NOTICE UNDER SCHEDULE VI CHAPTER XI, RULE 2 (I) OF
THE CITY OF KARACHI MUNICIPAL ACT 1933.Karachi 10th October 1935

Re:- Plot No 6/2 M.M. 2 Machhi Miani Gr.

PLAN SHOWING THE PROPOSED BUILDING
ON PLOT NO. 6/2 M.M.2 MACHI MAINI Qr

SITE PLAN

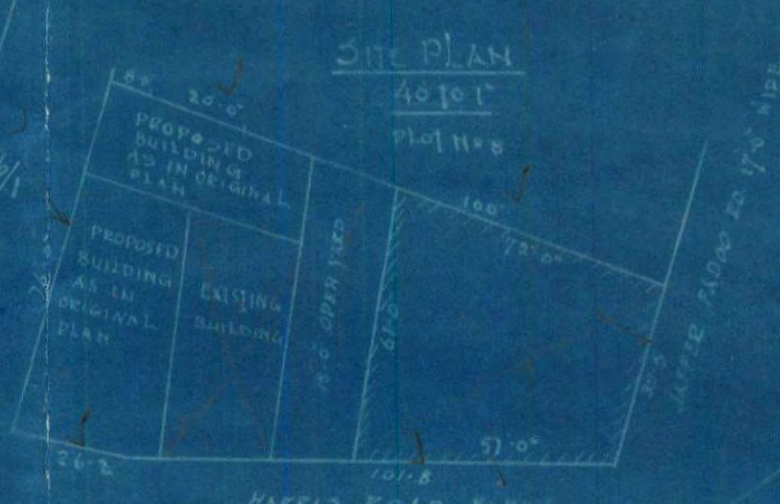
Re. no. 1. The site plan must not confuse as shown.

Re. 1. The site plan must be corrected and made more clear.

(2) site plan requires corrections (as per corrections made on the site plan in red ink)

1. Site-plan is misleading. It is not understood as to why different portions are marked A, B, C etc. An enclosure shown within the 15'0 open yard cannot also be understood.

1. Site-plan is misleading. It is not understood as to why different portions are marked 'A' 'B' 'C' etc. An enclosure shown ~~in~~ within the 15'-0 open yard cannot also be understood.
2. Height of the existing building must be given and the width of the open yard regulated in accordance therewith.
3. The height of the building beyond the 40' line from the Harris Rd. cannot exceed twice the width of Jaffer Fudoo Rd.
4. Kitchens have no ventilators.
5. Permission of the owner of the private drain be obtained before plans can be approved.
6. ^{plan} site/requires corrections (as per corrections made on the site plan in red ink).

1 to 4 Complied with.

ELEVATION

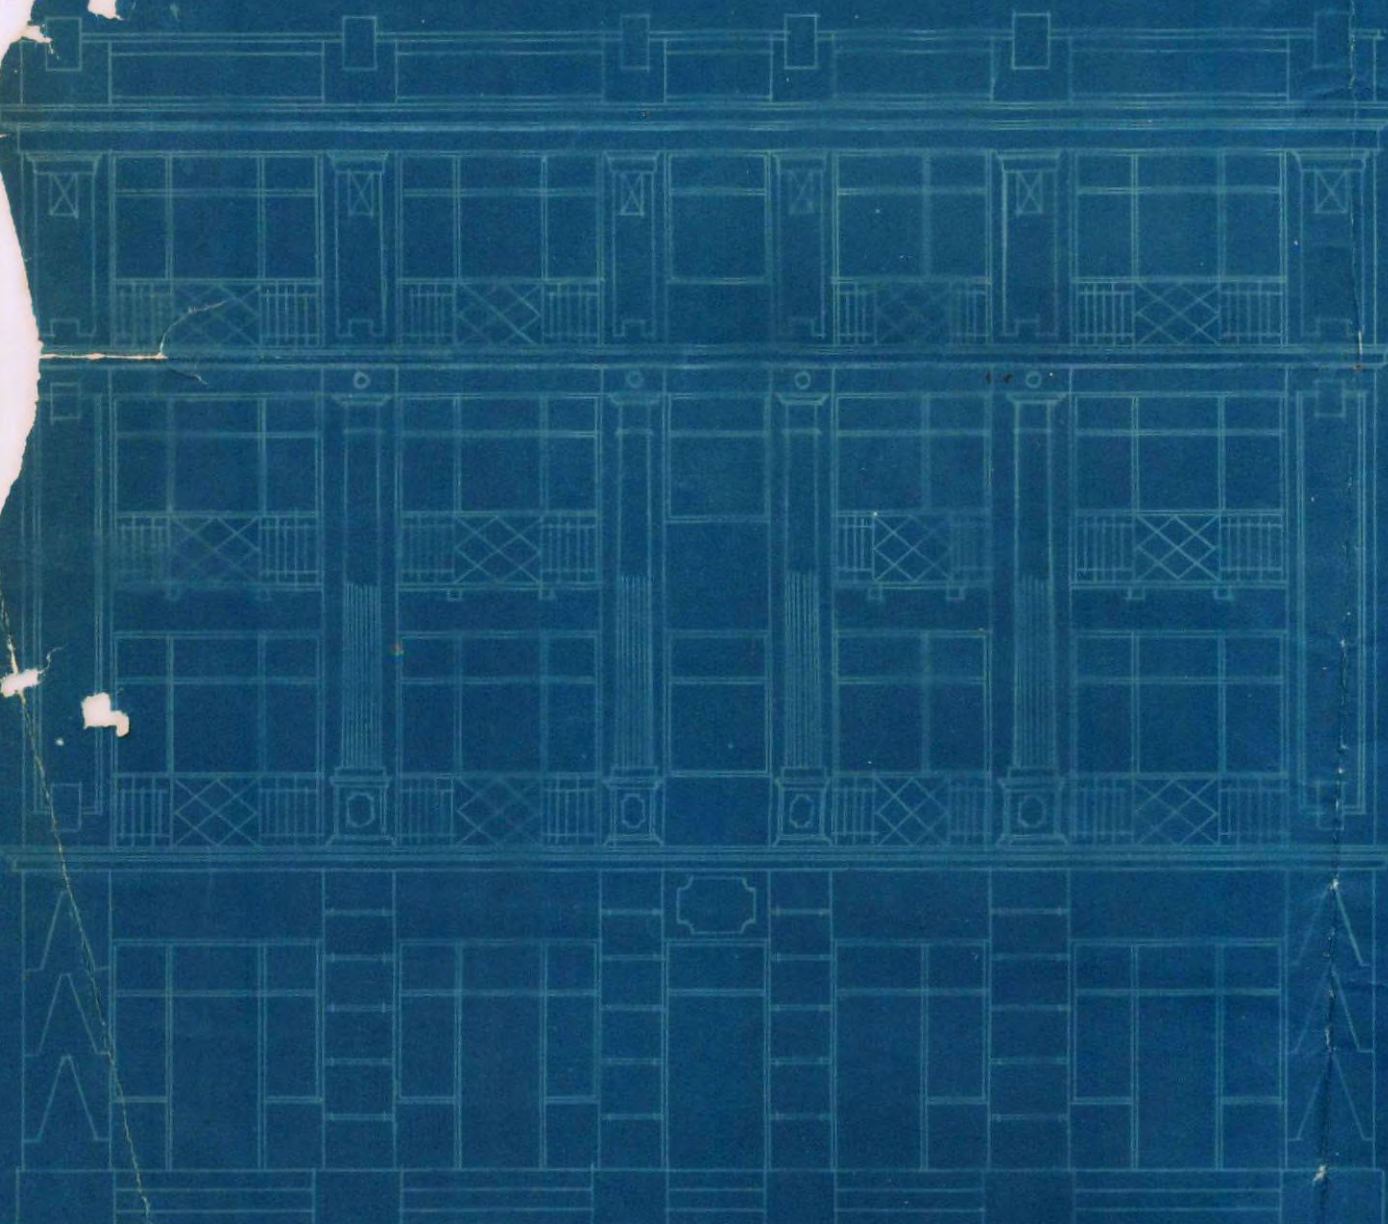
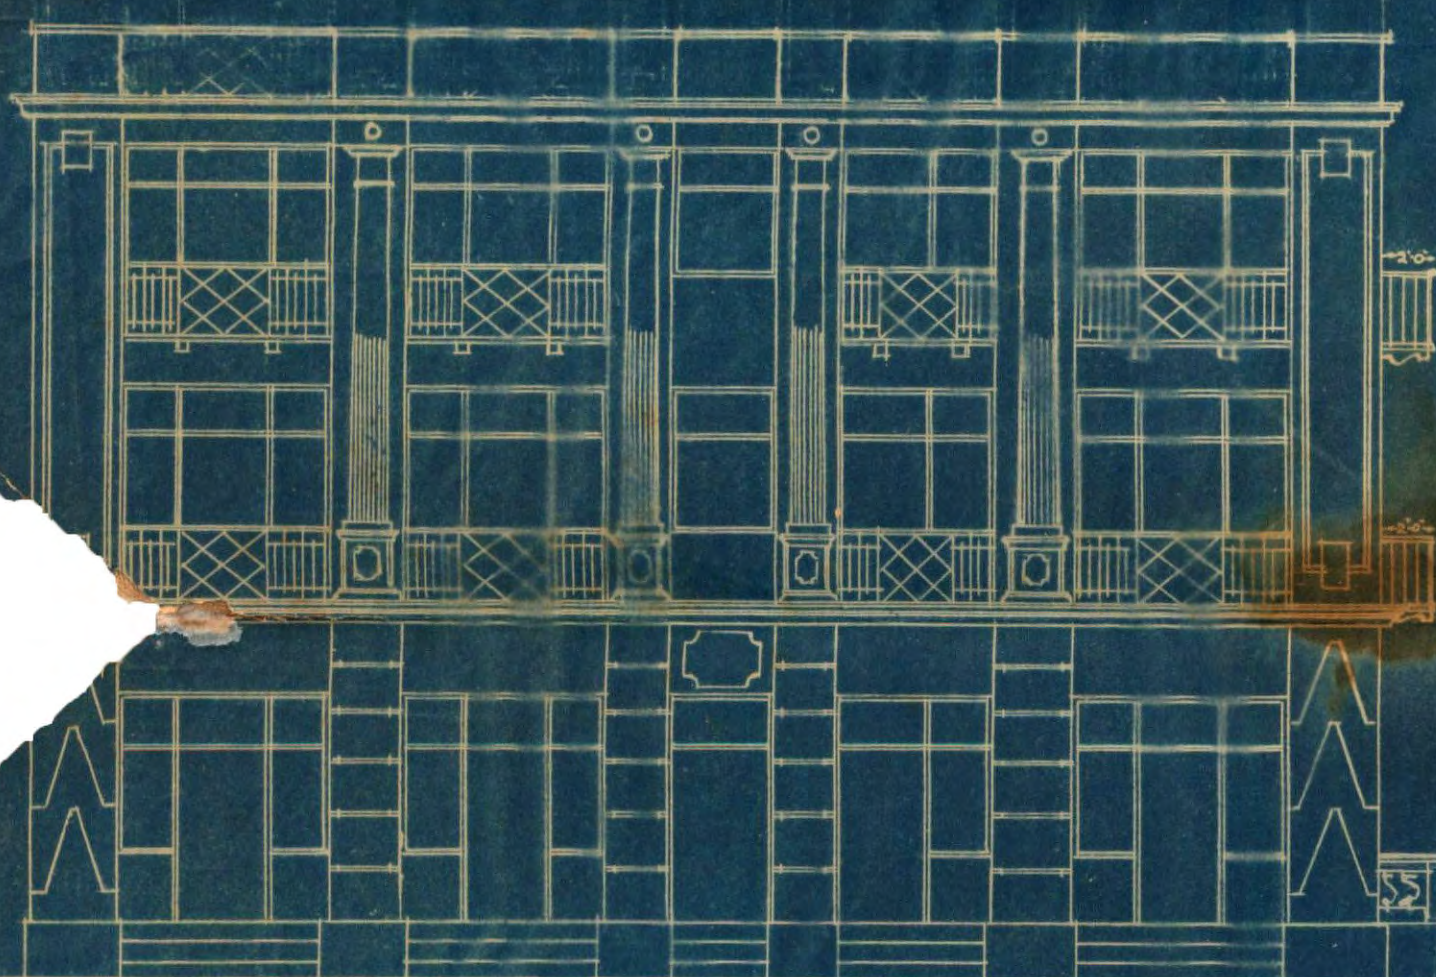
Reply that Byelaw 233(3) clearly speaks of 'wider' & not the 'smaller', therefore his reading of the Byelaw is not understood. - It is not understood from where he brings the word 'smaller' in place of 'wider'.

1. Bye Law 233 (3) clearly speaks of "wider" and not the "smaller" of paragraph 3 of your letter ~~xxxxxxx~~ under reply and therefore your reading of the Bye Law is not understood. It is not understood from where you bring the word "smaller" in place of "wider".
2. For a height of 44' the open space cannot be less than 14ft

3. The height of the building beyond the 40' line from the Harris Road cannot exceed twice the rear width of Jaffer Tundo Road.

1. Complied with.
2. In addition to the central open space ^{a further open} is shown at "A"
which makes the building very well lighted.
3. The frontage of the plot on the narrower street is only
39.5 Ft, hence the allowable height can be regulated according
~~now~~ to the width of the Harris Rd, and hence the proposed
height is permissible.

1. The gallery will be filled in with the earth-filling upto the level of the plat-form, as soon as, this building is constructed. This will remove the obstruction of the plat-forms.
2. The open has been further increased to 10'6" as against 8'-6" before.
3. Regarding the third objection I have to state that the rule regarding plots abutting on two roads allows of the proposed height along 40'-0" of the smaller street. Drawing a line at right- angles to this street at a distance of 40'-0" from the corner, (as shown in ~~the~~ green) it will be seen that the whole building is ~~available~~ allowable in accordance with the greater height. It will be rather queer

to built a building with a facing on the smaller road of the full greater height, while the interior, which in no way defects this small road, of a smaller height. Therefore considering the actual intention of the rule I hope you will be kind enough to approve the plans now.
